Immaculate Conception CES New Universal Washroom

ADDENDUM #1

Project No: 25223

Project: Immaculate Conception Universal Washroom
76 Robinson St.

INTERIOR ELEVATIONS AND DETAILS

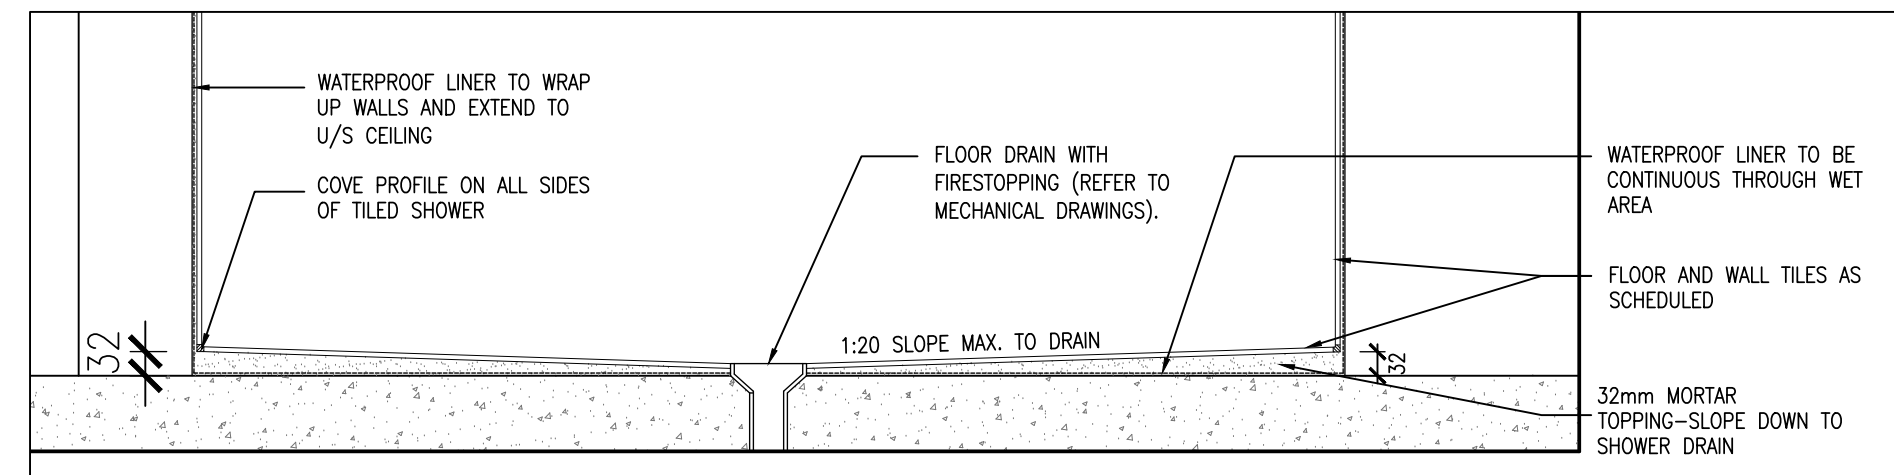
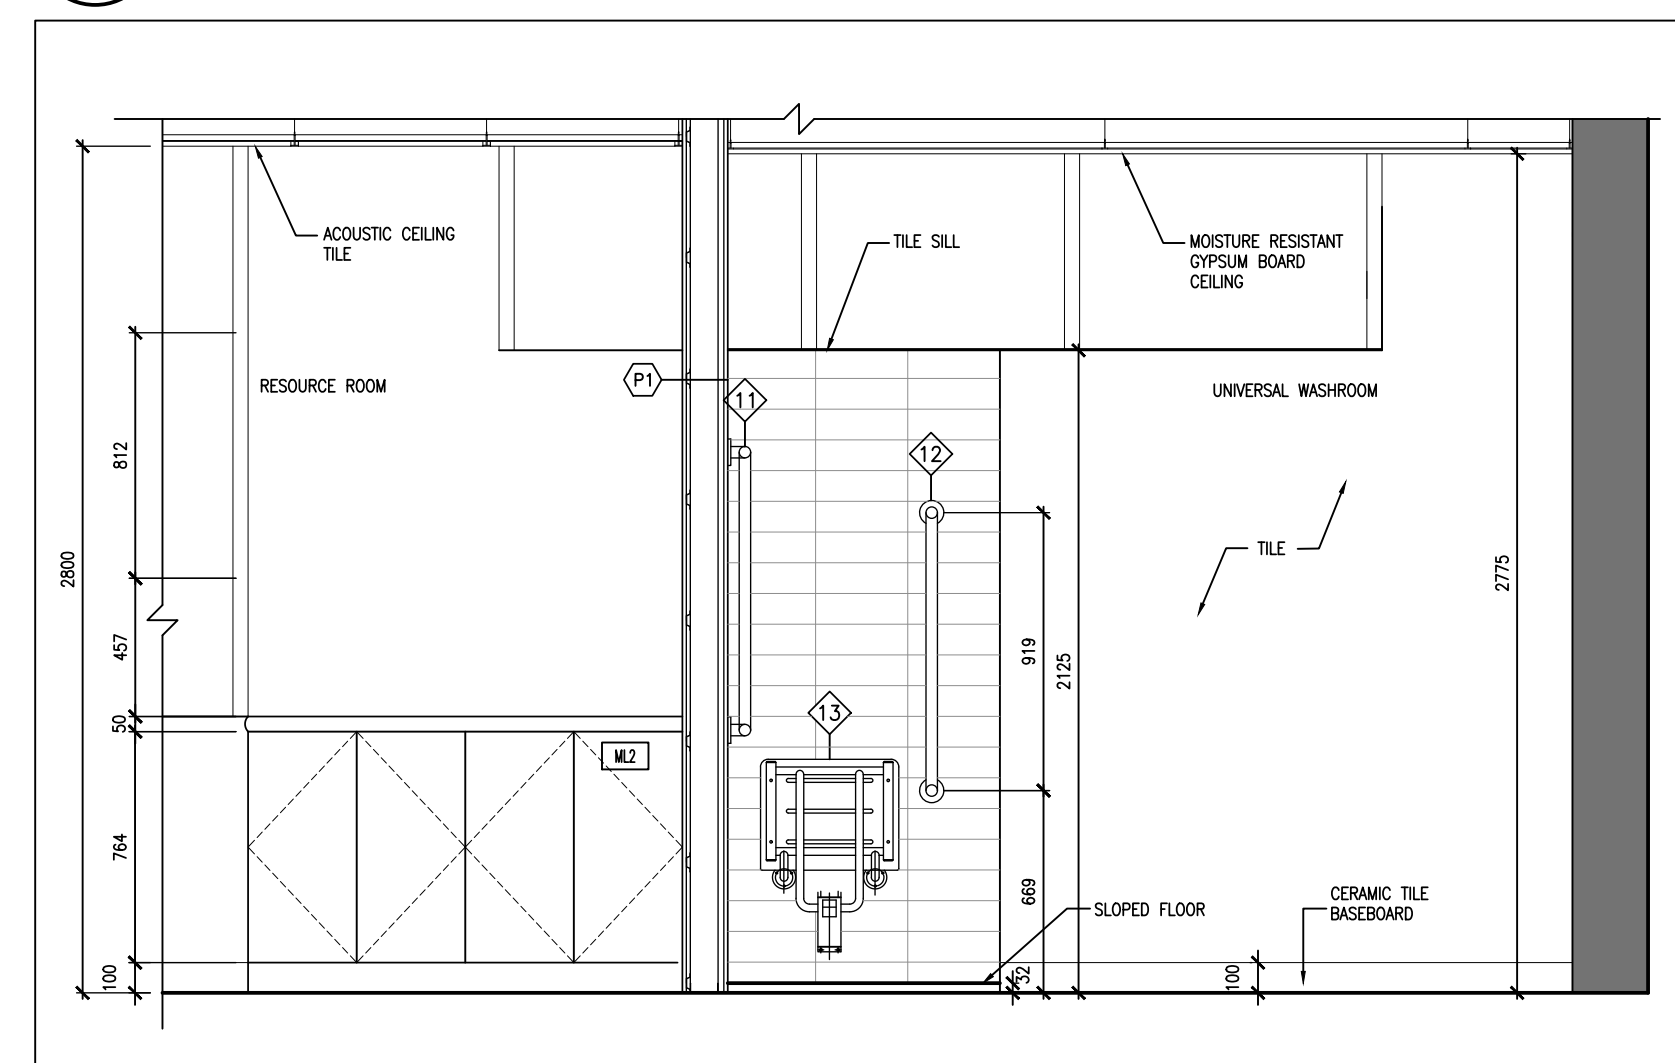
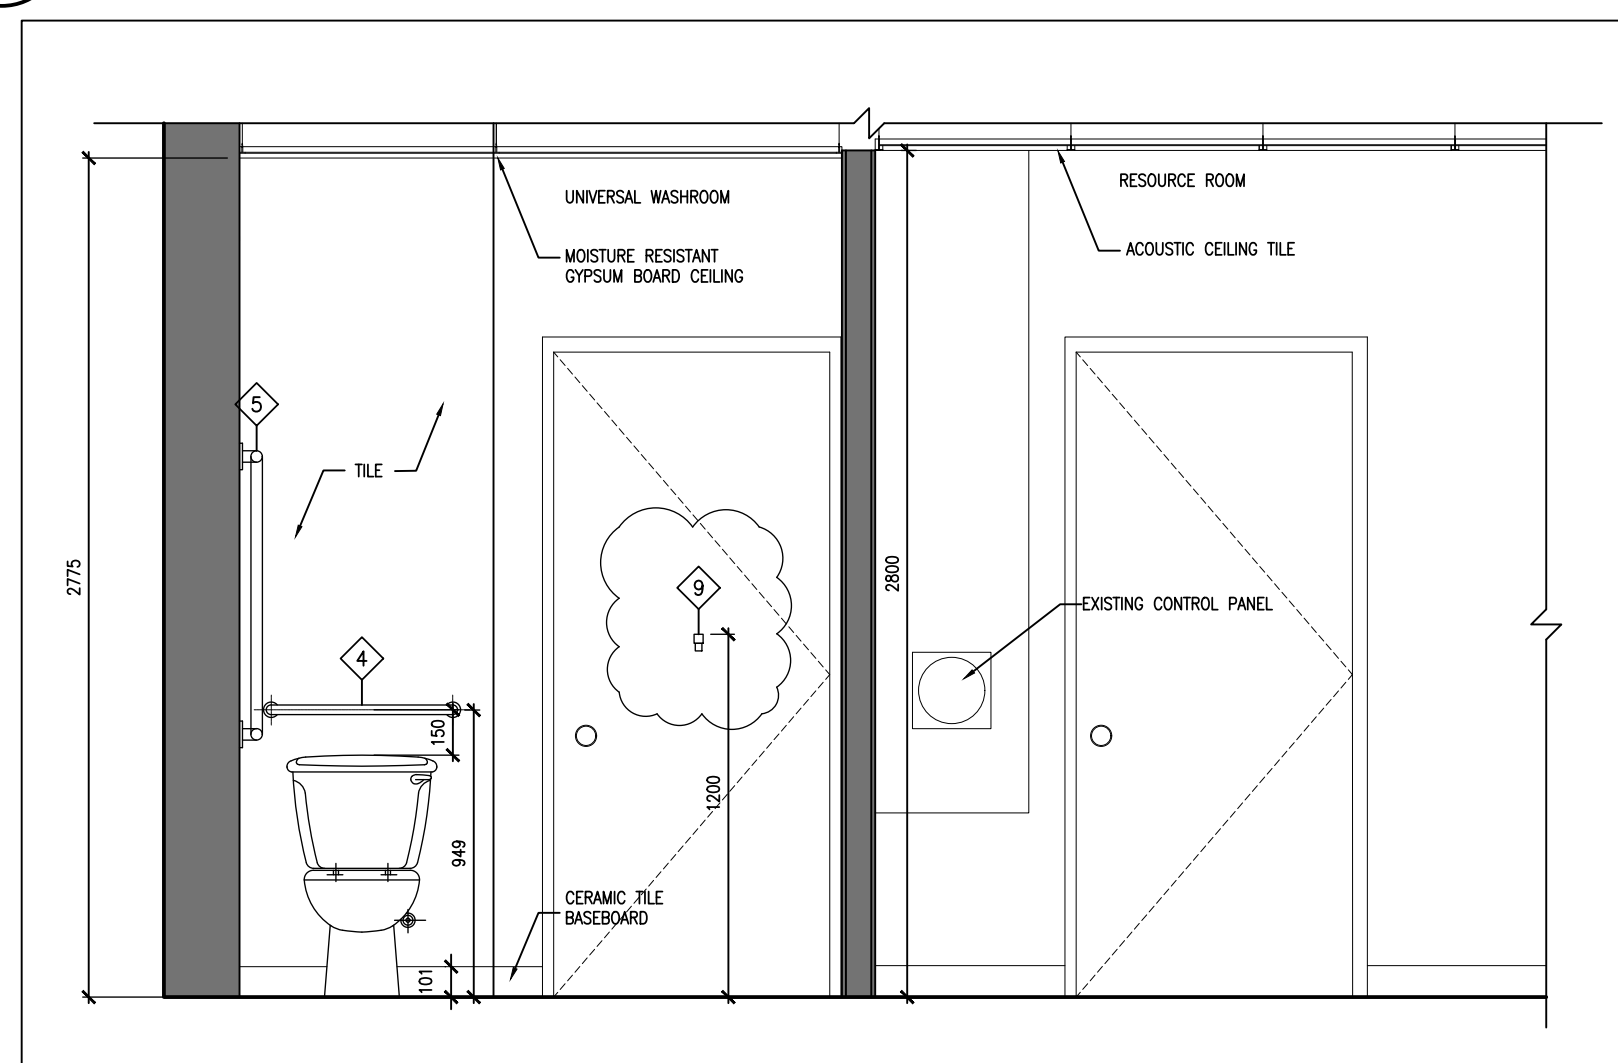
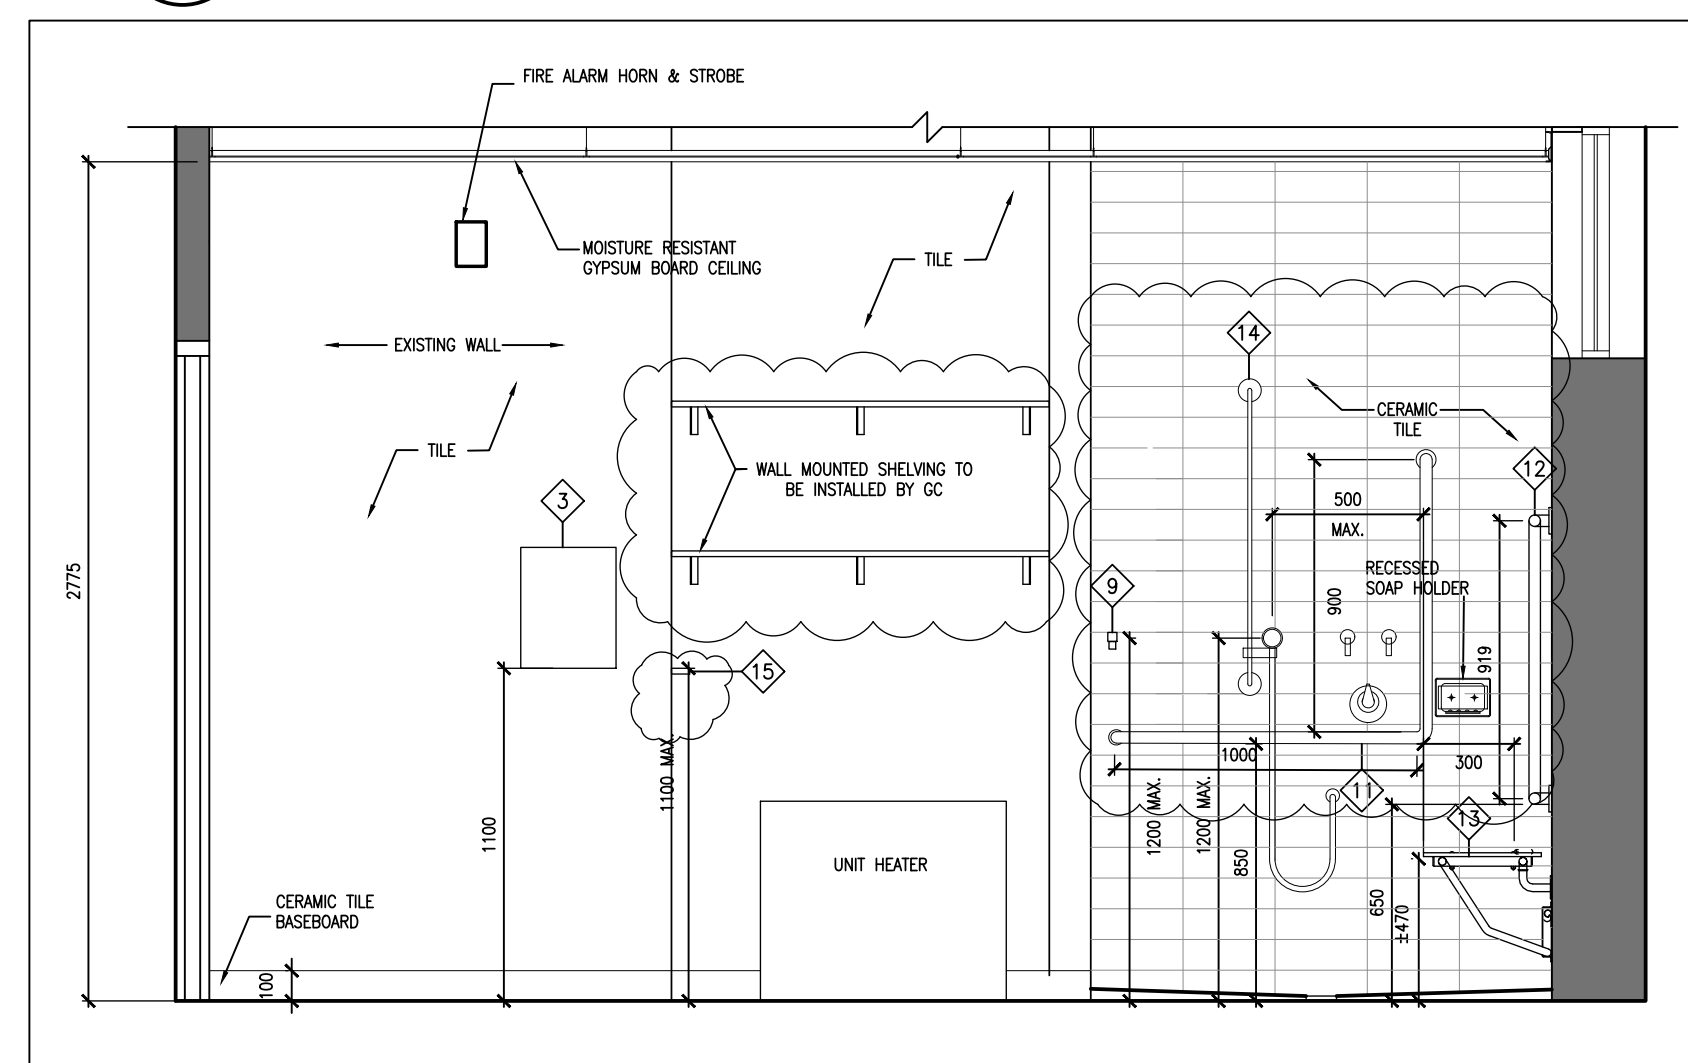
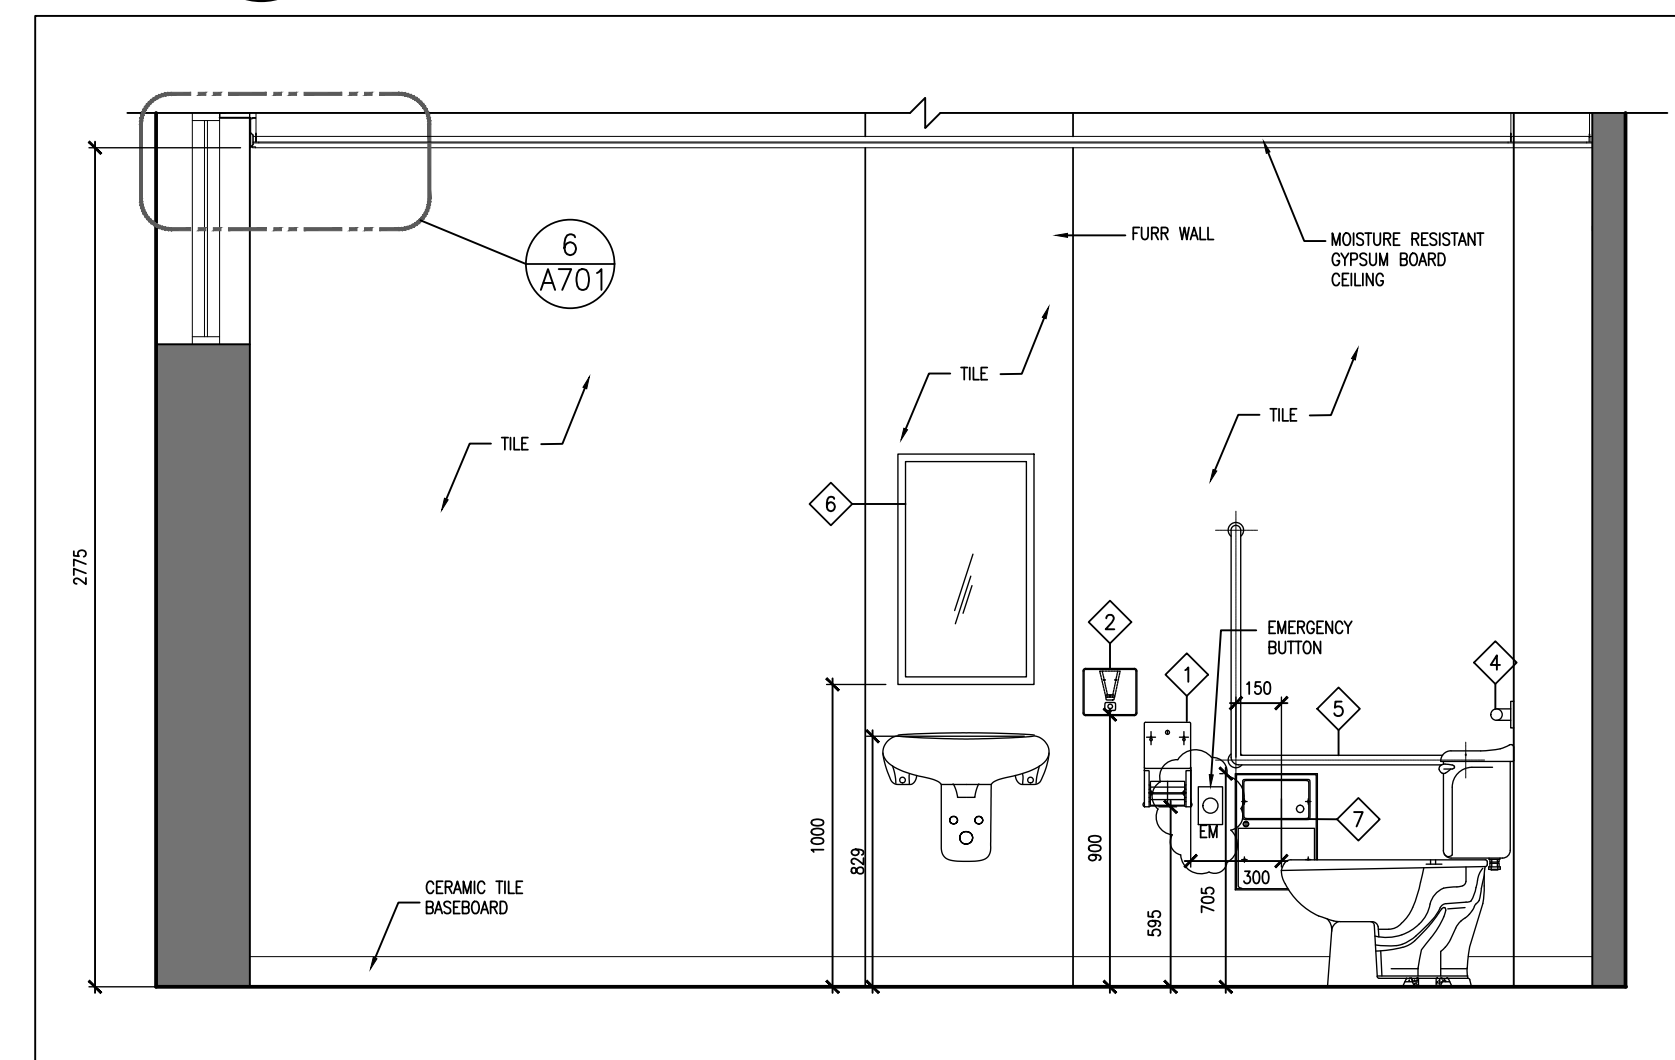
Question 2: 1. Detail 8/A701 shows batt insulation at P1 assembly, but it is not noted in the assemblies. Can you please confirm that we should include batt insulation
2. Division 9 specifications note that walls are to use 6 inch steel studs but the assemblies note 3 5/8 steel studs. Can you please confirm which item we are to carry?

Answer 2: .1 Confirmed to utilize comfort batt within the P1 wall assembly
.2 Confirmed to utilize 92mm studs as noted on the wall assemblies.
